DASY8/6 Module WPT

PIA INQUIRY

Compliance Testing against SAR
and MPE Limits (V1.2 August 2025)

Response to FCC's Questions/Comments about KDB Inquiry 959118

Figure 2: H-field probe with pickup loops of diameter d for the three vector components above the windings of a WPT coil. The probe tip touches the cover of the WPT system and is located at distance z_0 from the coil. The probe reference location is in the probe center at $0.5d + z_0$.

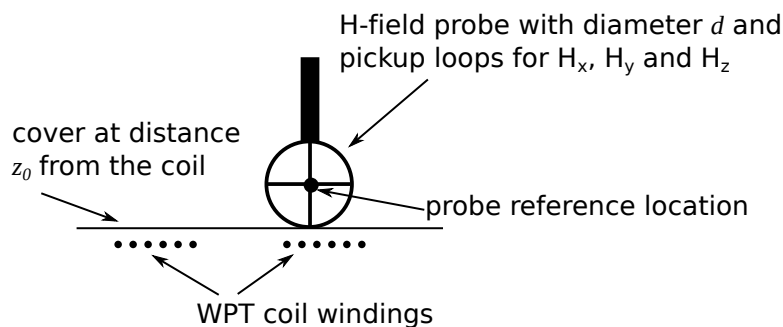
While we expect that this measurement will work quite well for coils that provide a relatively uniform field along the axis over a characteristic length in the order of the radius of the probe, it would be interesting to see what could be a more challenging case for smaller coils, where the field lines are expected to exhibit a more pronounced to turn off-axis, even at the small distance of the probe radius.

In other words, let's consider r the radius of the probe, R the radius of the coil located in $z=0$ with z being the direction of the coil axis; one can measure the field exactly by placing the center of the probe at $z=r$, and extrapolate the field at $z=0$ (contact position with the coil plane). If $R \gg r$, then the field lines will be relatively "straight" at $z=r$. But if $R \approx r$, the curvature of the field lines will be more pronounced, and one would expect a lesser accuracy of the field estimate at $z=0$.

Figure 2 shows a probe with three pick-up loops measuring the H-field at distance d above the cover of a WPT system. The deviation of the measured field integrated over the areas of the three loops from the actual H-field maximum at the cover of the WPT system for the 70 different generic WPT coils evaluated in [2] is given in Figure 3 as a function of the probe diameter. The errors of the 70 different cases is normalized to the mean value for their respective radii. The mean values are given as figures in the plots below the respective error distributions. The deviations of a gradient probe, which uses a pick-up loop with 5 mm radius for the measurements of surface fields, are given for comparison [2]. This has already been evaluated in [9]. The required measurement distance of $1.7 \times$ the probe diameter cited in [9] greatly reduces the uncertainty of the measurements but does not allow evaluation of the exposures at smaller distances with reasonable uncertainty.

The results shown in Figure 3 demonstrate that the uncertainty of the H-field measured by three-axis probes with large pick-up loops increases as a function of the probe diameter. For a diameter of 100 mm, the uncertainty can exceed 20 dB. The deviations of the gradient probe are within 2 dB for the evaluated coils, as it utilizes small sensors as close as possible to the probe tip. In comparison, the preliminary uncertainty of DASY8/6 Module WPT V2.4 measurements based on the H-field information in the entire volume for the field reconstruction is 0.6 dB.

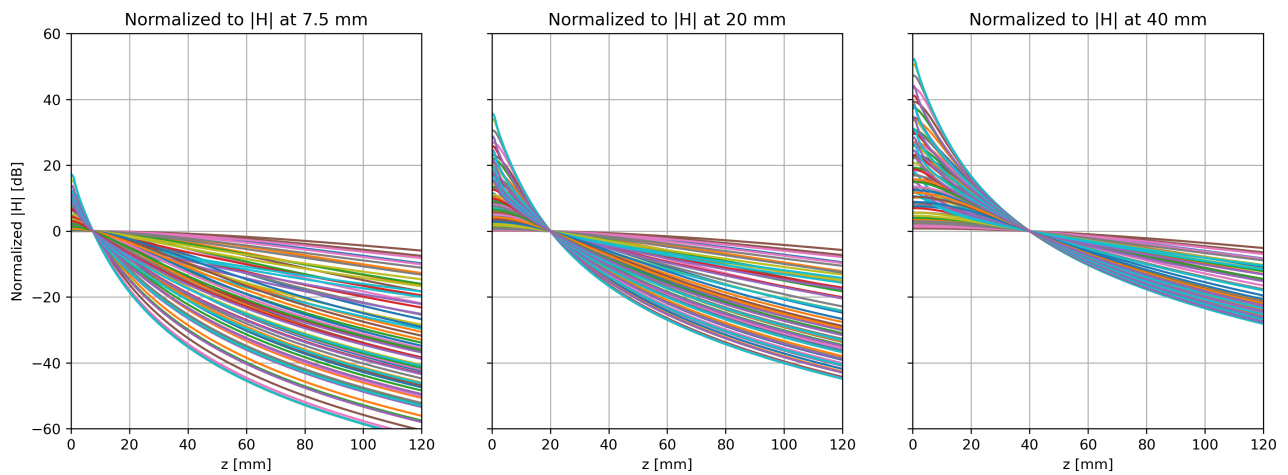
We outlined in the previous reply the validation of the extrapolation method (that is, using the probe without the field reconstruction), and we expanded that in more detail in the latest Apr 2024 TCBC workshop (Presentation 4.2).

Figure 1 shows that if we are able to measure the field accurately at 20 mm, the field at the surface is between 0 dB and 38 dB (1–80 times) of the value at 20 mm. If the field is accurately measured at 7.5 mm, the variation is reduced to 0 dB and 17 dB (1–7 times) of the value at 7.5 mm. In other words, the measurement at 7.5 mm is not sufficient to determine the field at the surface with an uncertainty of $\pm 30\%$ as requested by FCC [1].

We believe that the procedure meets the FCC criteria of $\pm 30\%$. It has been validated using several thousands different realistic H-field decays/profiles.

If we would measure as suggested at 7.5 mm and take another measurement with an offset of 7.5 mm (i.e., at 15 mm from the surface) and use this information to find an optimal extrapolation function to estimate the field at the surface, the results would be more accurate since the gradient would be more accurate. However, the final uncertainty would be prone to user errors and affected by the uncertainty of the 7.5 mm shift.
